**The Morecambe Offshore Windfarm Generation Assets Development Consent Order  
Application**

**Deadline 6 submission by Spirit Energy Production UK Limited**  
**Response to the Applicant's Deadline 5 and Deadline 5A Submissions**

**EN010121**  
**Unique Reference: 20049981**

<b>Date</b>	15 April 2025
-------------	---------------

**Figure 1: Sectors available for undertaking flights via CPC with 1.5nm buffer and IMC Corridor.**

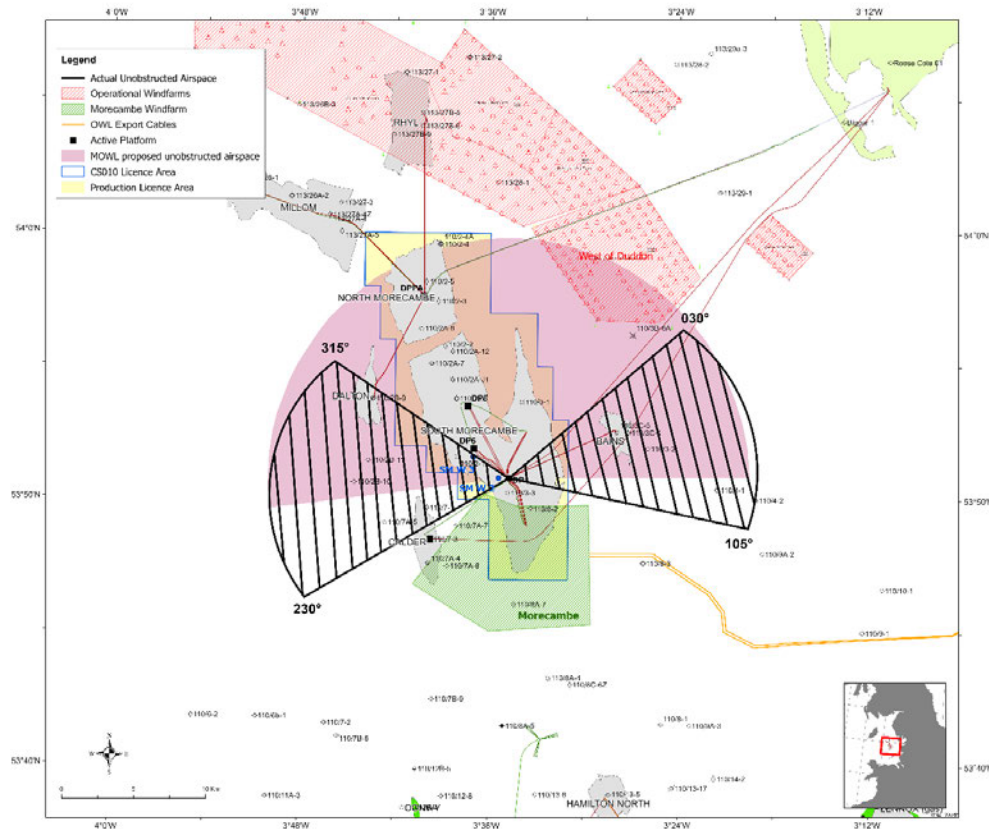
- 2.31 Sector 1: from 230 to 315 degrees in which Spirit can approach in VMC from the west with winds under 30 kts.
- 2.32 Sector 2: from 30 to 105 degrees in which Spirit can approach in VMC from the east with winds under 20 kts.

- 2.33 In addition to the above, Spirit reiterates its position that the proposed UK CAA regulation changes will restrict all IMC operations to O&G facilities in under 3nm distance from any wind farm array.

**Figure 2 Maximum time offshore by season**

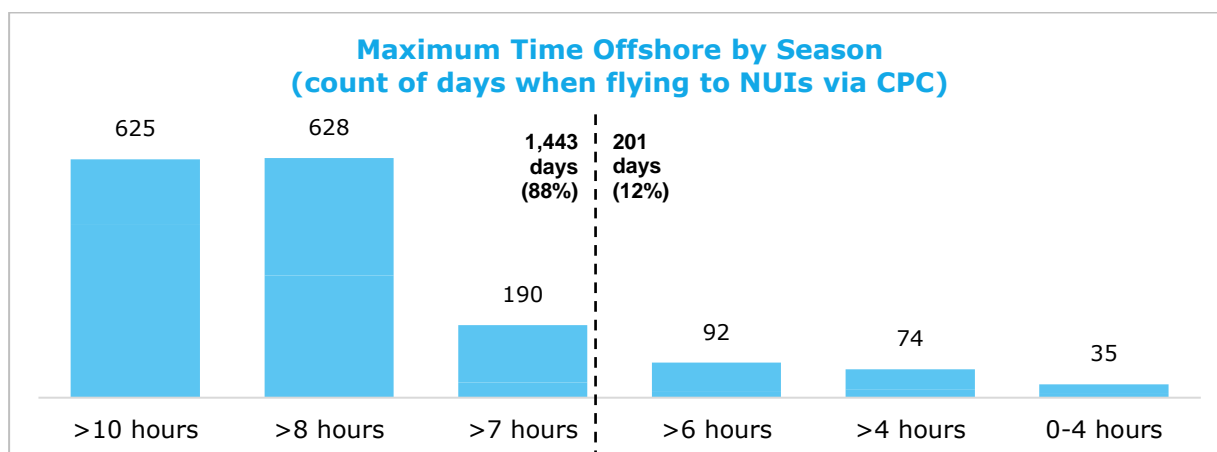
- 3.19 However, Spirit maintains that the analysis should be based on a minimum of 7 hours' time offshore for a working day. As detailed in Figure 2, 88% of Spirit's offshore working days at NUIs are longer than 7 hours. Only 2% of Spirit's working days on NUIs are less than 4 hours. NUI maintenance activities have significant set up and close times (e.g. for toolbox talks etc – as detailed in paragraph 3.14 of Spirit's D5 submission). A working day of 4 hours would effectively mean that Spirit's NUI intervention teams would have very little time to undertake work. Trips allowing only 4 hours or less on the asset are usually for quick fixes and not part of the planned maintenance which must be undertaken in accordance with the permitted scope of work on the relevant date. For this reason, Spirit operates on the basis that 7 hours is the minimum time offshore available when planning its maintenance activities and considers this the appropriate threshold to assessing time offshore lost as a result of the Project.

- 3.20 In either case, a key conclusion of the analysis is the bearing wind direction would have if the windfarm were situated within the minimum safe distance calculated by Spirit's technical experts (1.9nm). The number of working days lost due to the combination of the windfarm in closer proximity than 1.9nm and the wind restrictions applicable in those circumstances is untenable for Spirit to maintain its operations (22% based on 7 hour working days, and 16% based on 4 hour working days).

**Figure 3 MNZ Wells**

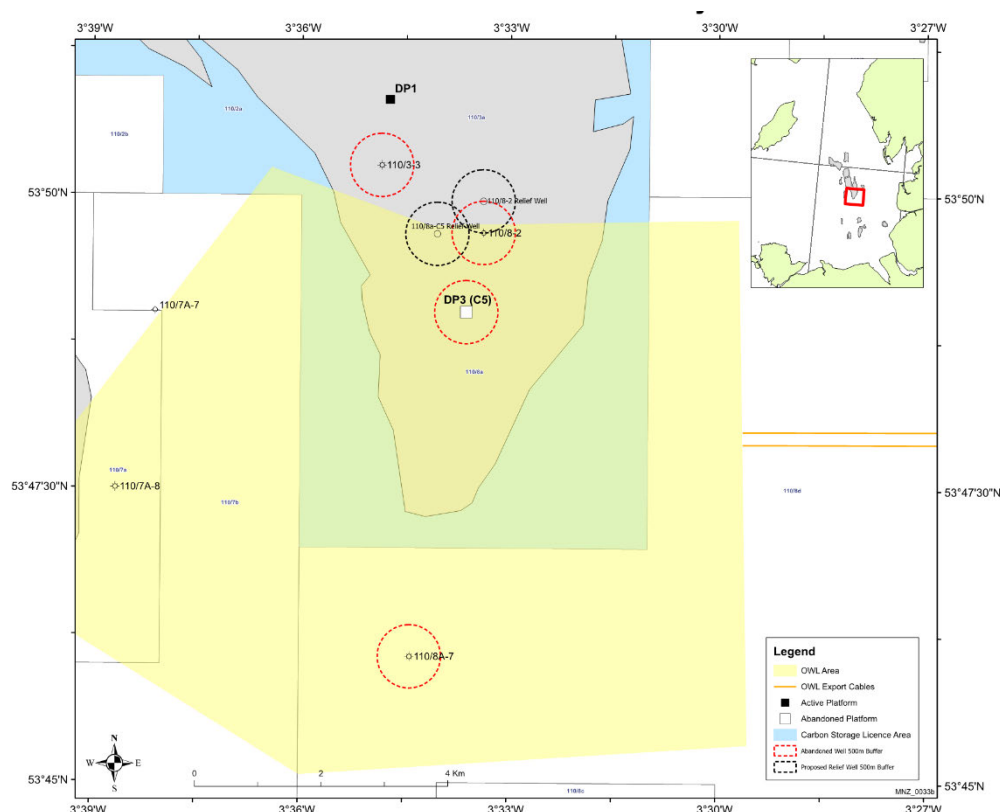
- 7.12 The NSTA requires Spirit to undertake a well integrity assessment during the Appraise phase of the MNZ Carbon Storage Licence to update the containment risk assessment and inform the Monitoring Plan and Corrective Measures Plan. The NSTA requires that 65 wells in total are included in the assessment, including seven legacy wells that are offset from South Morecambe, including 110/8A-7 (approximately 2.5 km offset from the storage site), 110/3C-5 (approximately 5km offset from the storage site), 110/3B-6A (approximately 8km from the storage site) and 113/29a-3 (more than 25km from the storage site) (see Figure 3 MNZ Wells for the location of the legacy wells within the MOWL area). Following the well integrity assessment, Spirit will receive guidance from the NSTA on the wells that will need to be monitored (in a Monitoring Plan, MP) during the carbon storage project. Spirit will also need to demonstrate remediation plans in a Corrective Measures Plan (CMP) for those wells. The wells 110/8A-7, 110/8-2 and the wells drilled from DP3 are abandoned as per OEUK guidelines. However, as the NSTA requires Spirit to review these wells in the well integrity assessment, the assumption at this time is that they will be subject to monitoring and provision in the CMP until otherwise determined by the NSTA. In relation to well 110/8A-7 and Xodus' analysis of the likelihood of CO2 reaching this well (section 3.2, Xodus MNZ Report), Spirit must remind the Applicant that it is the NSTA that will ultimately approve the monitoring and corrective measures requirements that are established in relation to this well. The only available corrective measure for 110/8A-7 is using a rig, hence the need for protective provisions enabling rig access, as further described below.

7.13 In terms of use of the monitoring methods available to Spirit, Xodus has indicated that Spirit has discounted seismic surveying as a method of monitoring (paragraph 268, Xodus MNZ Report). This is only correct for conformance monitoring within the storage site, as Spirit will not be able to detect any seismic difference between CO<sub>2</sub> and methane in the gas field area. However, if CO<sub>2</sub> leaks outside of the storage site, seismic will be an effective tool for containment monitoring as the seismic response would be considerably different (CO<sub>2</sub> displacing brine). If, as operator of the carbon store, Spirit had evidence that CO<sub>2</sub> may be leaking (e.g. well monitoring showed pressures that were lower than expected), towed streamer seismic or OBN could be a tool that would allow Spirit to confirm this and map the leak, and therefore it is likely to be a suitable monitoring technology and is still in consideration for the MNZ Monitoring Plan. However, Spirit recognises that 3D seismic within the Project would be impossible and OBN would be extremely expensive, and so has already conceded that these would not be available within the Project area (but may still be a monitoring technology across the rest of the storage site). With regard to the assertion that an “*obvious solution*” for the placement of seabed concrete pads for 4D surveying would be the midpoint between turbine locations (section 3.1.2, Xodus MNZ Report), this has not yet been determined. The optimal placement will depend on the density and spatial configuration required to monitor the gravity changes, but also on seabed conditions (avoiding shifting sands for example). The work to establish the configuration on the layout of concrete pads still ongoing. Additionally, time lapse S DAS (seabed distributed acoustic sensing) is a form of seismic which has a receiver that may need to be deployed on the seafloor. This is also a technology that is under consideration for Spirit’s Monitoring Plan.
